DEPARTMENT OF ENVIRONMENTAL MANAGEMENT
 OFFICE OF WATER RESOURCES
 FRESHWATER WETLANDS PROGRAM
 APPROVED WITH CONDITIONS
 AS SPECIFIED IN THE LETTER OF APPROVAL
 DATED **MAR 17 2017** FILE # **16-0297**
 NO CHANGES ALLOWED WITHOUT PRIOR APPROVAL
 APPROVED PLANS MUST BE AT CONSTRUCTION SITE

Project Title:
**MELVILLE PONDS CAMPGROUND
 A.P. 43 & LOT 1A
 181 BRADFORD AVENUE
 PORTSMOUTH, RHODE ISLAND 02871**

Issued for:
 PERMITTING

Drawing Title:
LAYOUT AND UTILITY PLAN
SHEET 1

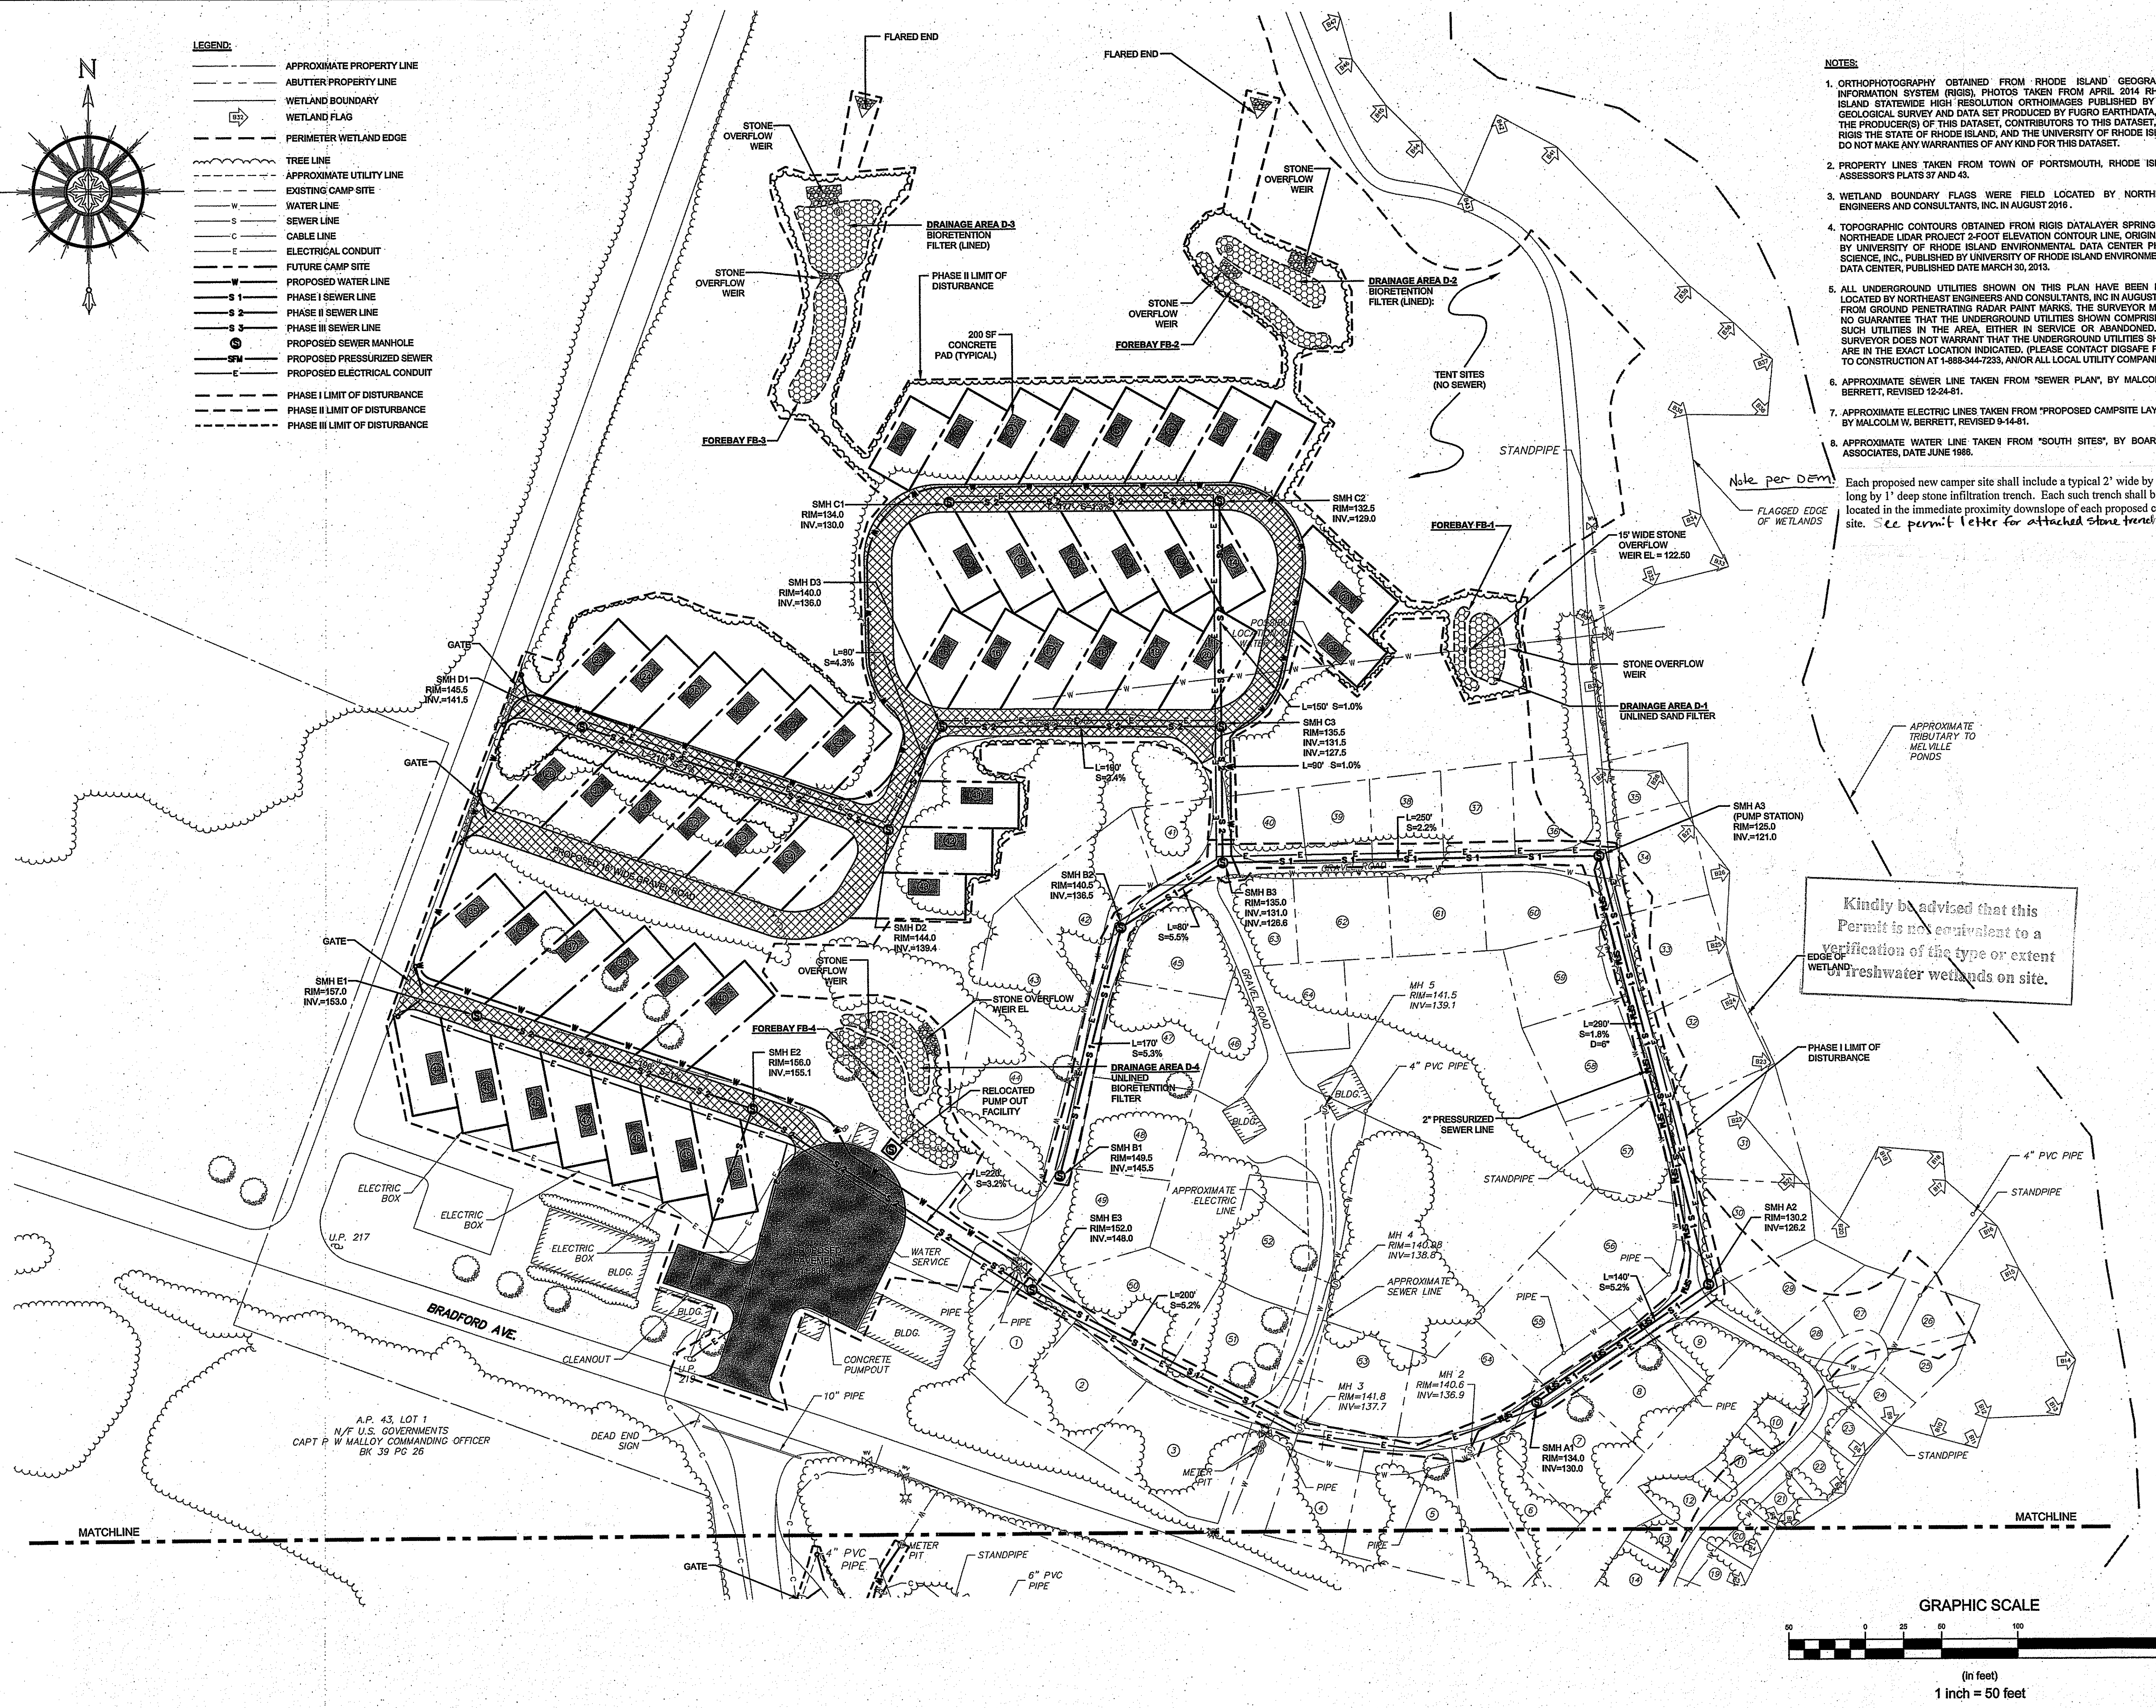
Note per DEM: Each proposed new camper site shall include a typical 2' wide by 10' long by 1' deep stone infiltration trench. Each such trench shall be located in the immediate proximity downslope of each proposed camper site. See permit letter for attached stone trench details.

Each proposed new camper site shall include a typical 2' wide by 10' long by 1' deep stone infiltration trench. Each such trench shall be located in the immediate proximity downslope of each proposed camper site. See permit letter for attached stone trench details.

Drawing Title:
**LAYOUT AND UTILITY PLAN
SHEET 2**

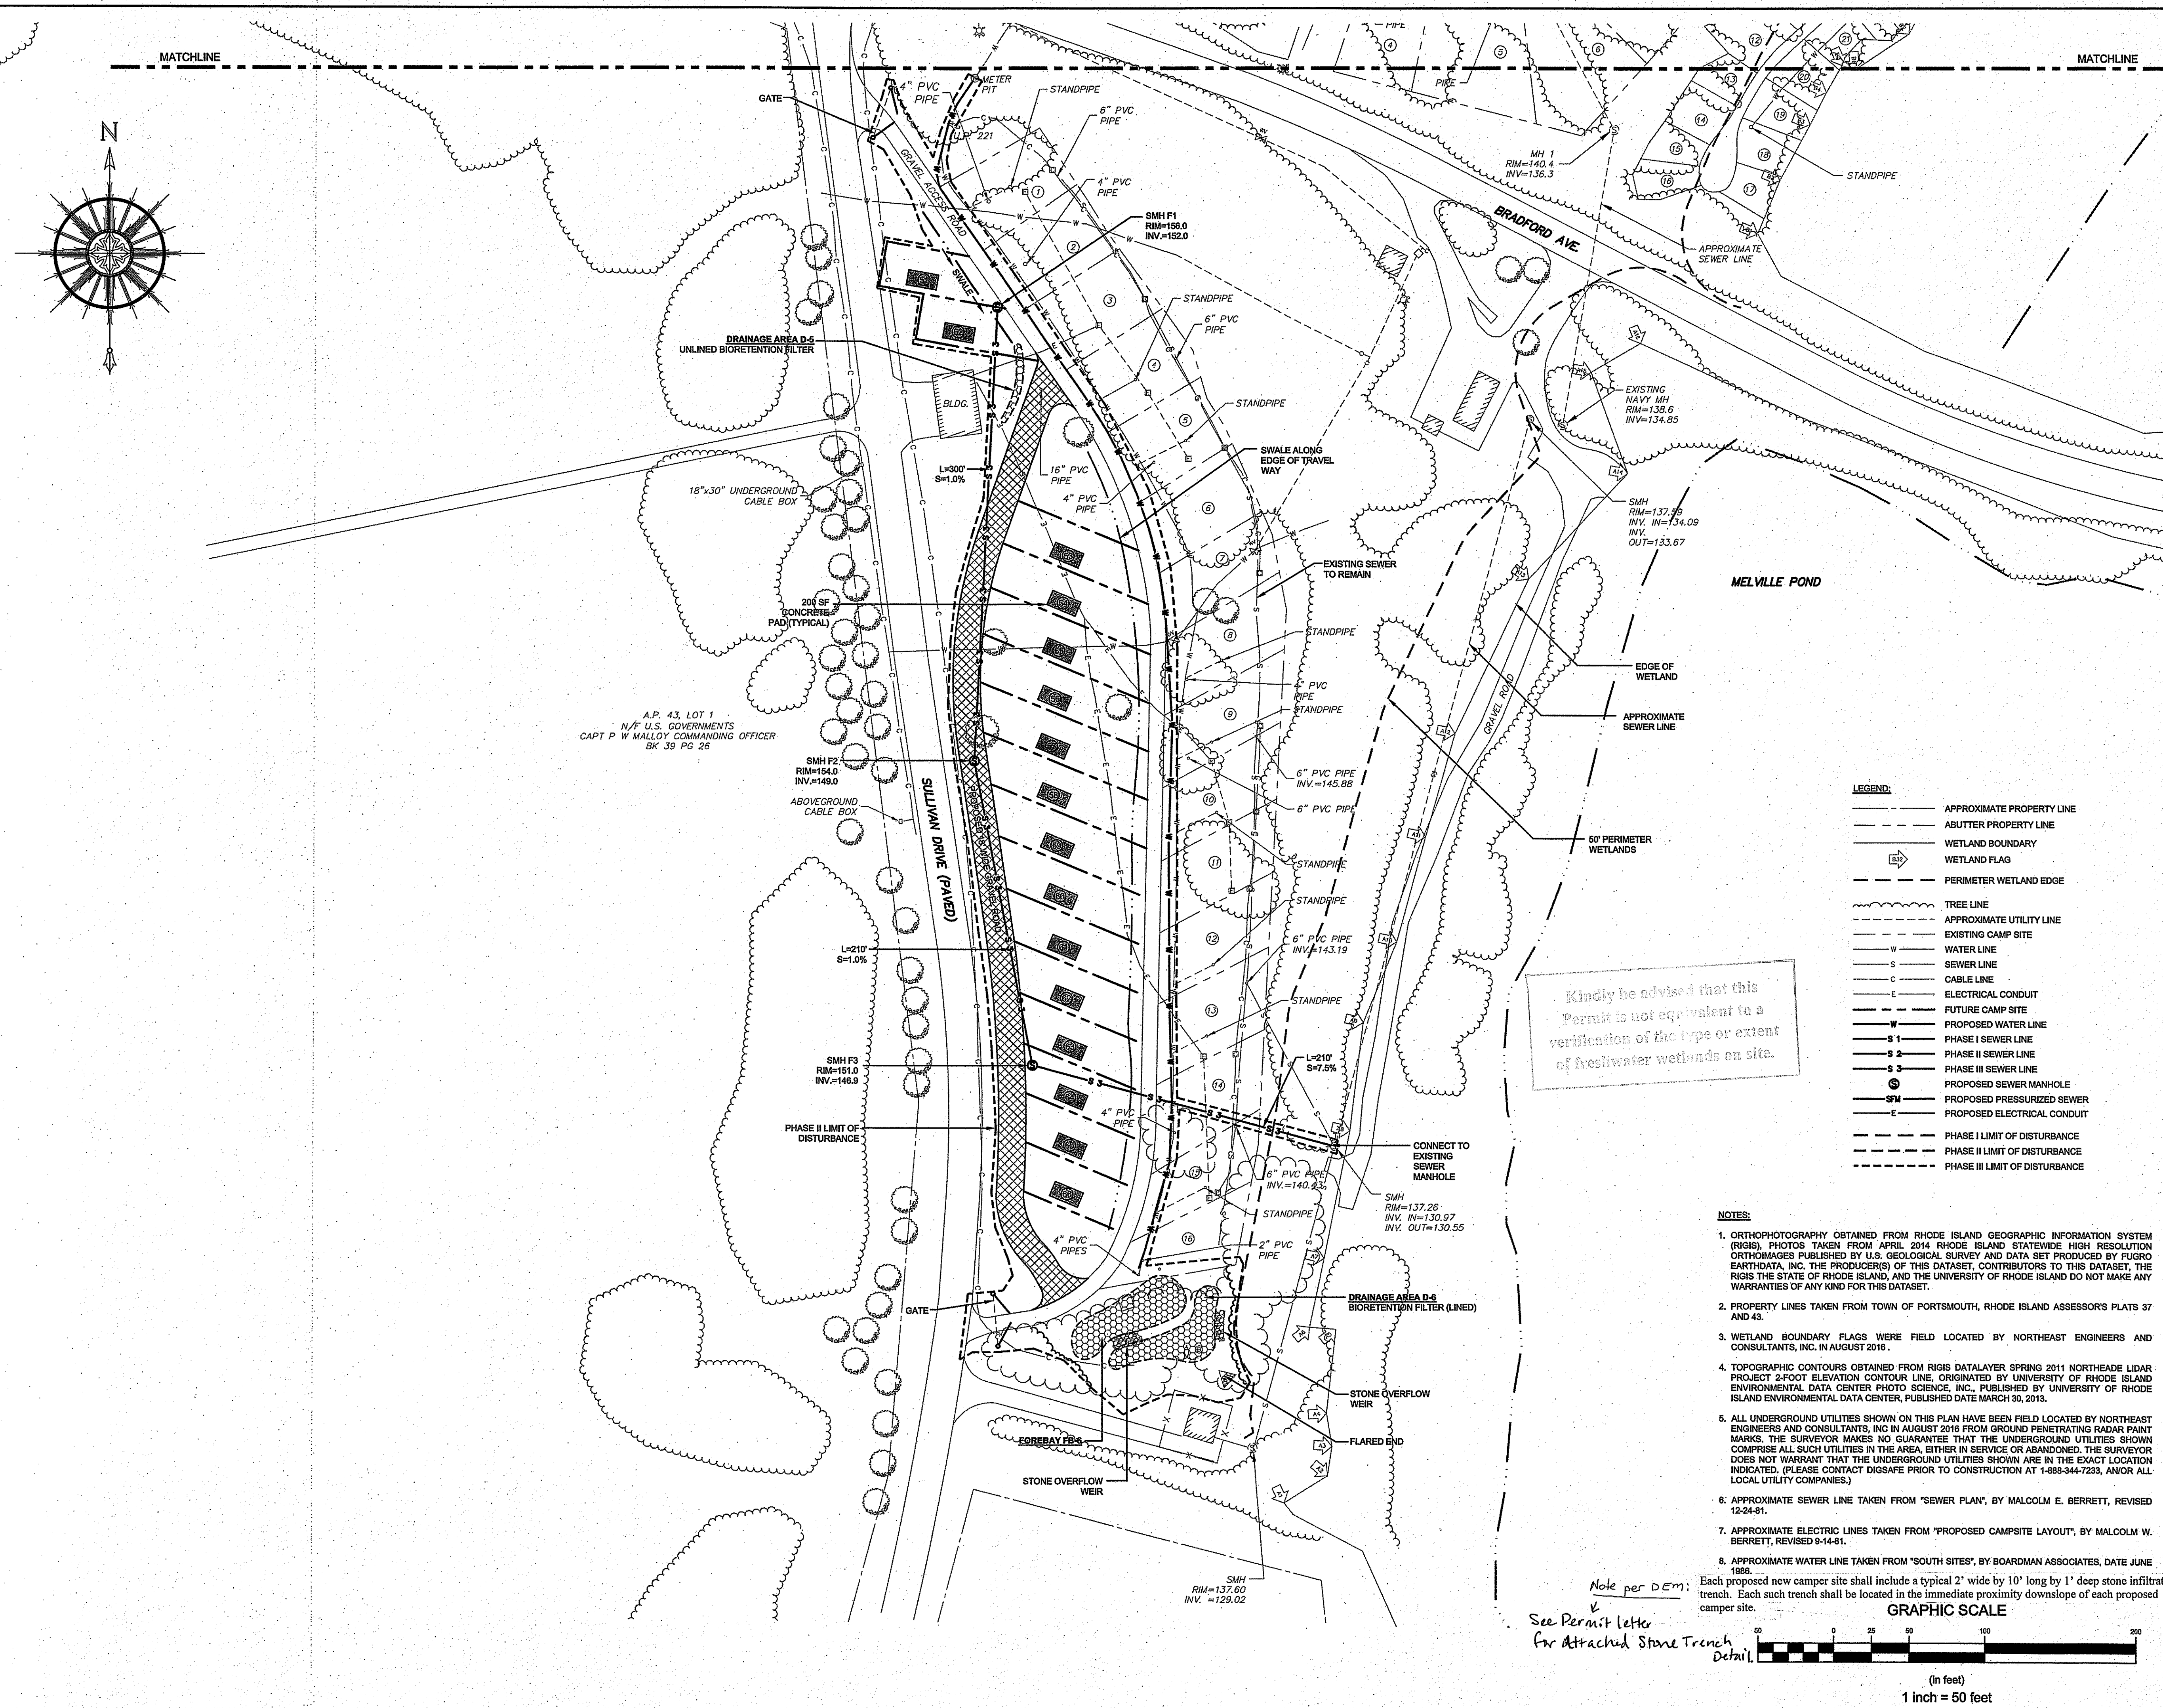
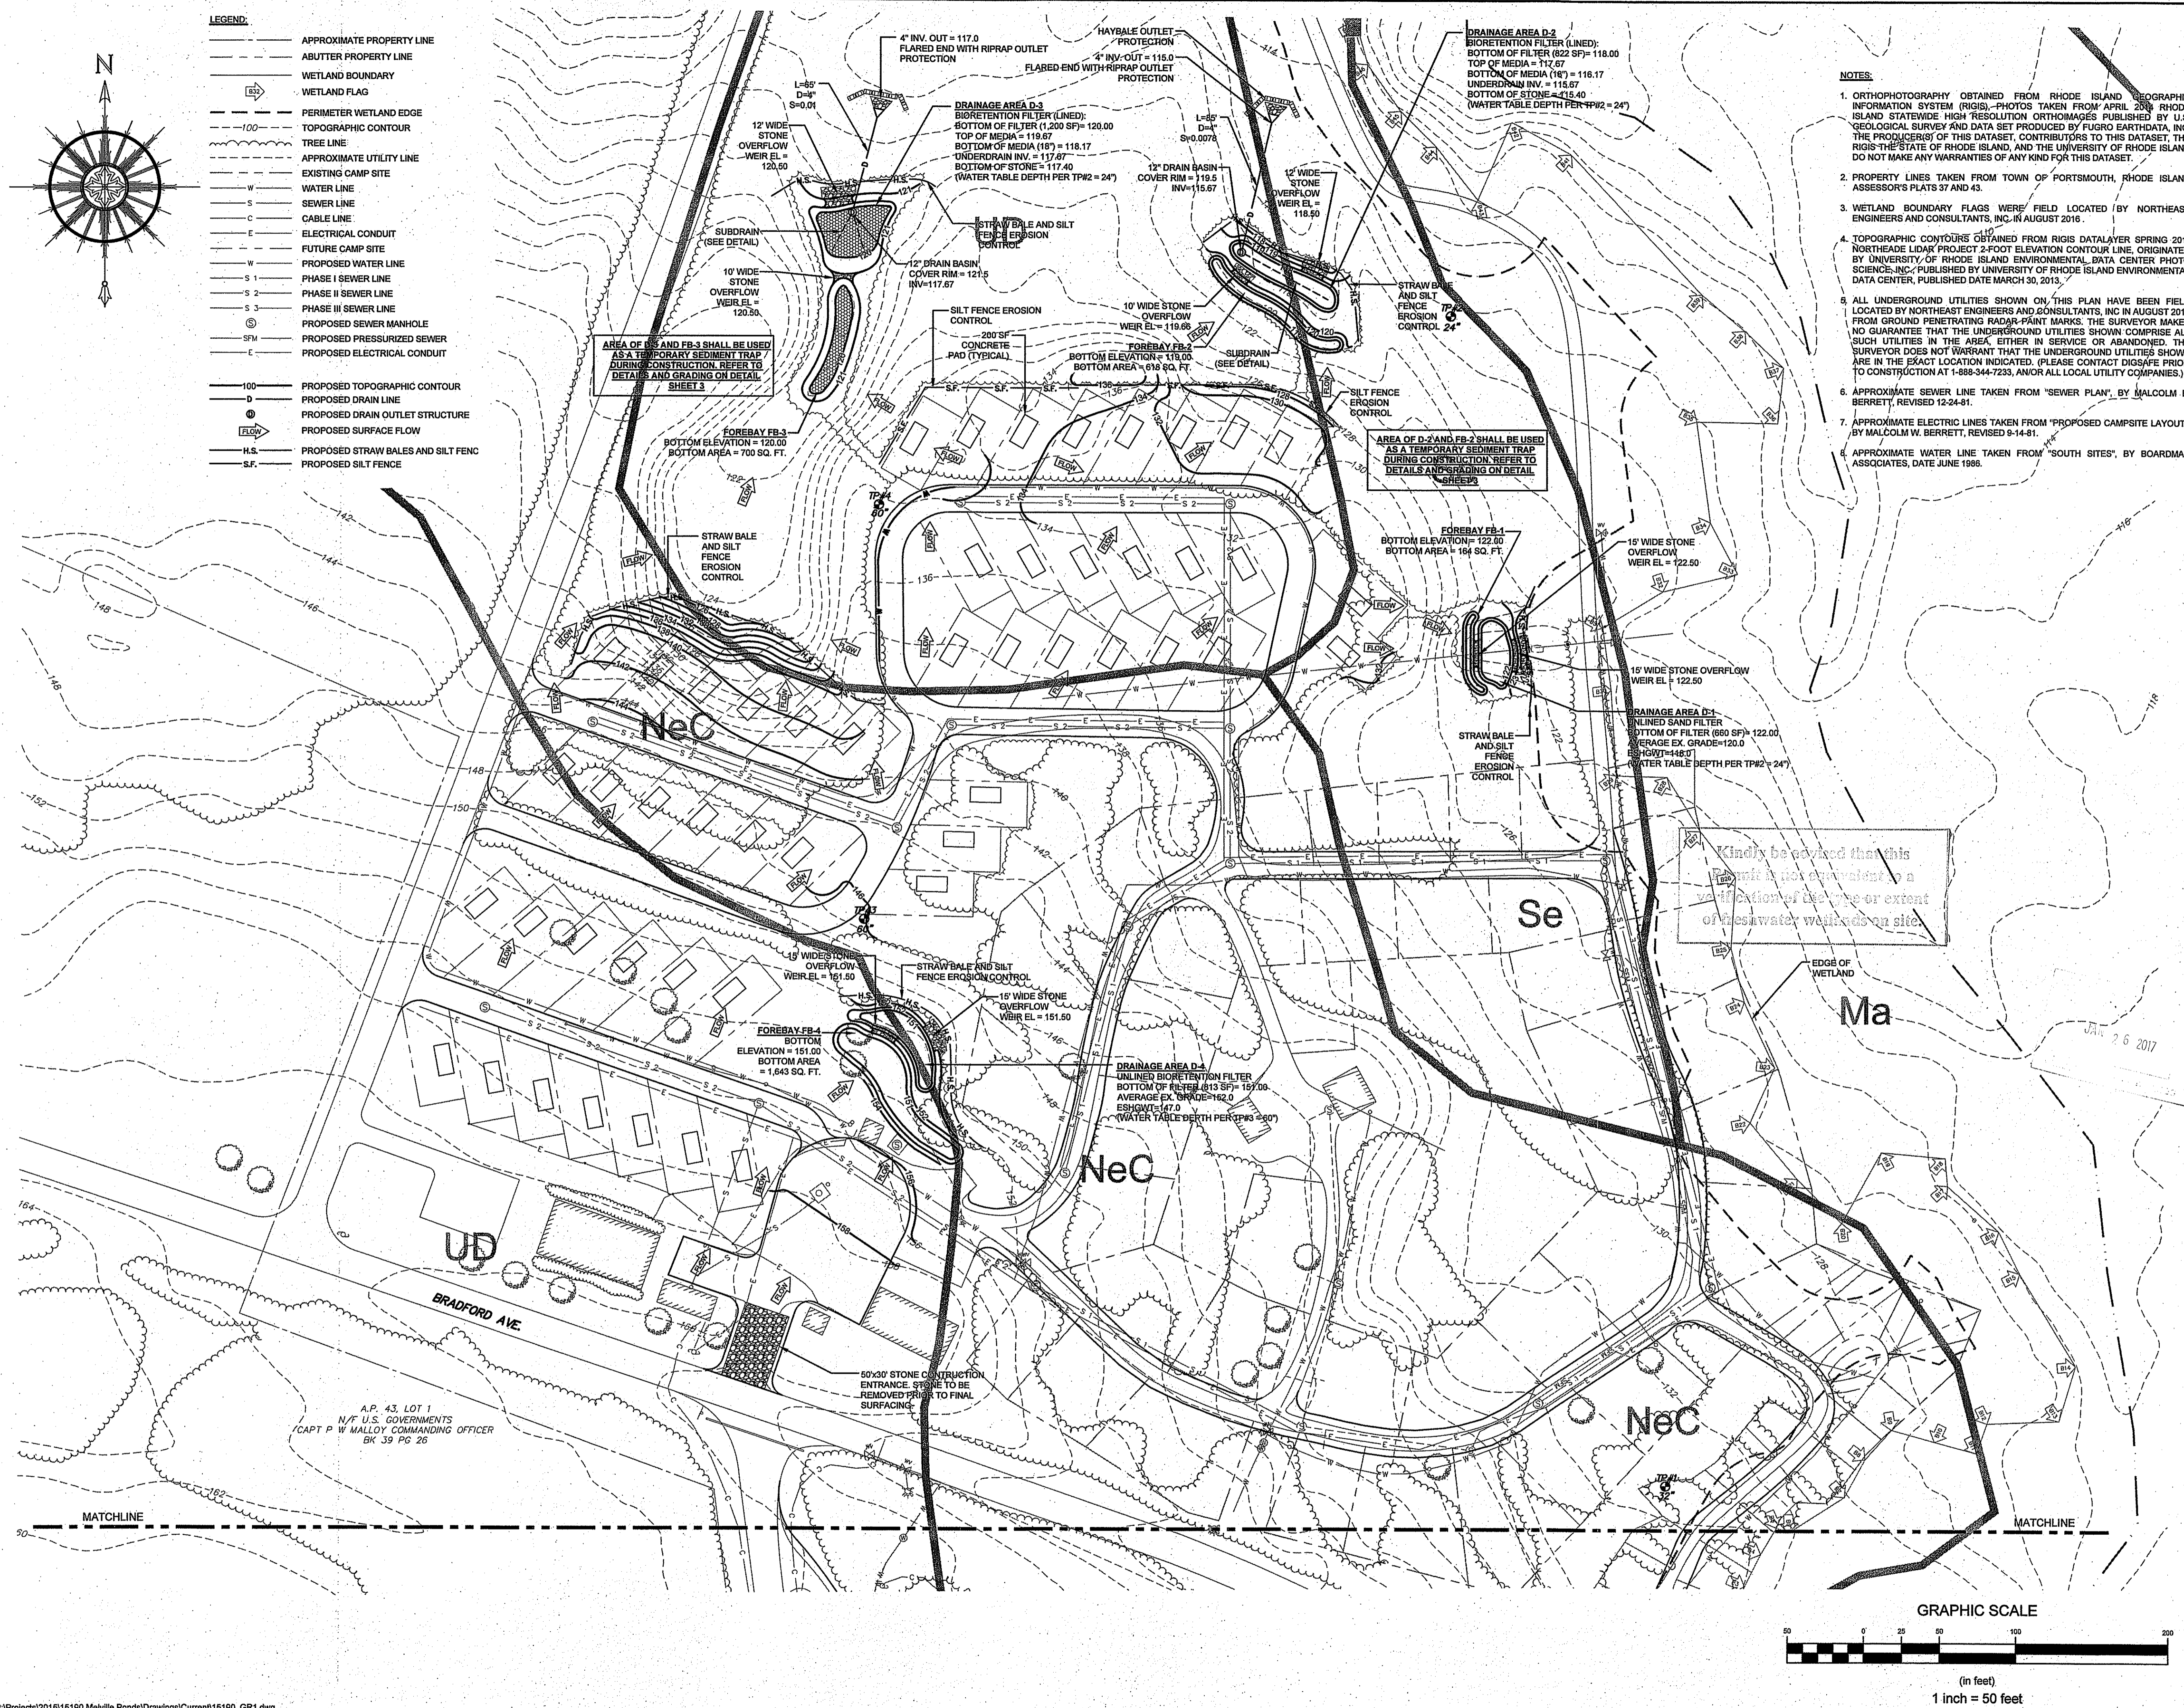
Note per DEM:
See Permit letter for Attached Stone Trench Detail.

Each proposed new camper site shall include a typical 2' wide by 10' long by 1' deep stone infiltration trench. Each such trench shall be located in the immediate proximity downslope of each proposed camper site.
